SUNDRY NOTICES AND REPORTS ON WELLS
Do not use this form for proposals to drill or to re-enter an abandoned well. Use form 3160-3 (APD) for such proposals.

8. Well Name and No.
POLO AOP FED 3

9. API Well No.
30-015-28169-00-S1

**Polo AOP Federal 3
30-015-28169
Yates Petroleum Corporation
Conditions of Approval**

Well Name: Polo.AOP Federal #3 Field: Dagger Draw
 Location: 660' FSL & 660' FWL Sec 10-19S-25E
 County: Eddy State: New Mexico
 GL: 3,483' Zero: KB:
 Spud Date: 7/15/1995 Completion Date: 8/25/1995
 Comments: API # 30015281690000

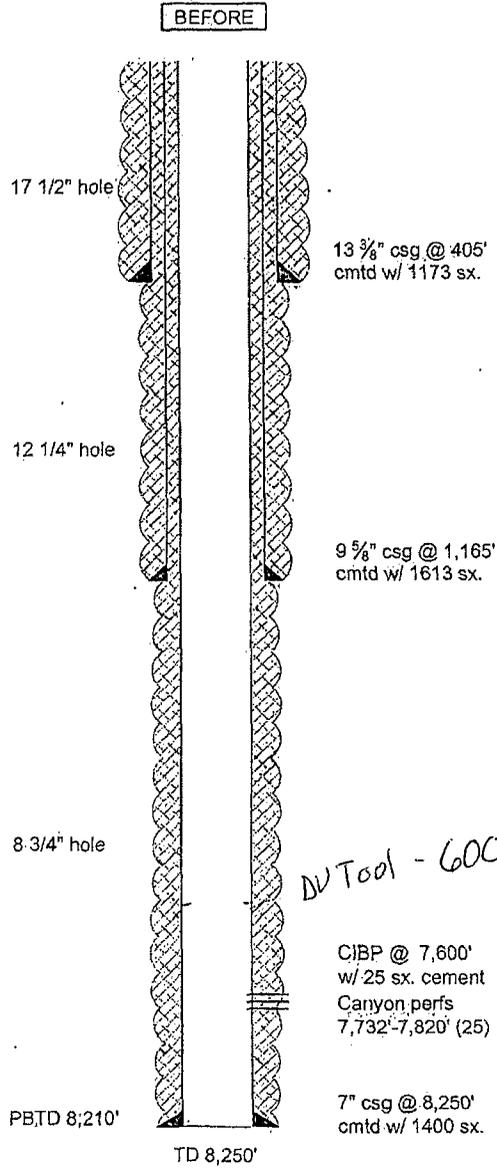
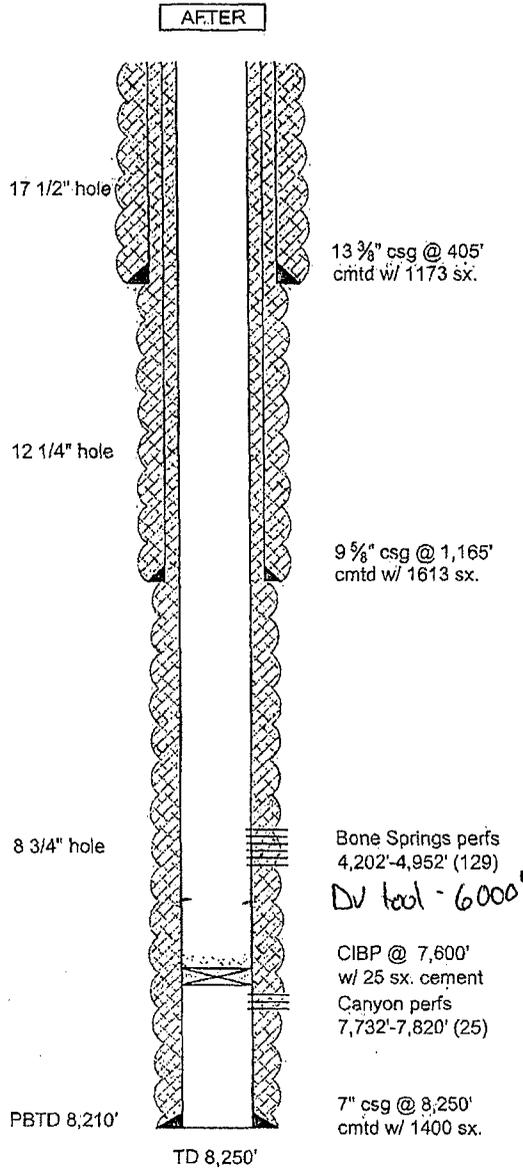
- 1. Operator shall set a CIBP at 7,680' and place 25 sacks Class H cement. WOC and tag.**
- 2. Operator shall spot a class C cement plug from 6050'-5606'. WOC and tag. (DV tool at 6000' and Wolfcamp at 5656')**

- 3. Must conduct a casing integrity test before perforating and fracturing. Submit results to BLM. The CIT is to be performed on the production casing to max treating pressure. Notify BLM if test fails.**
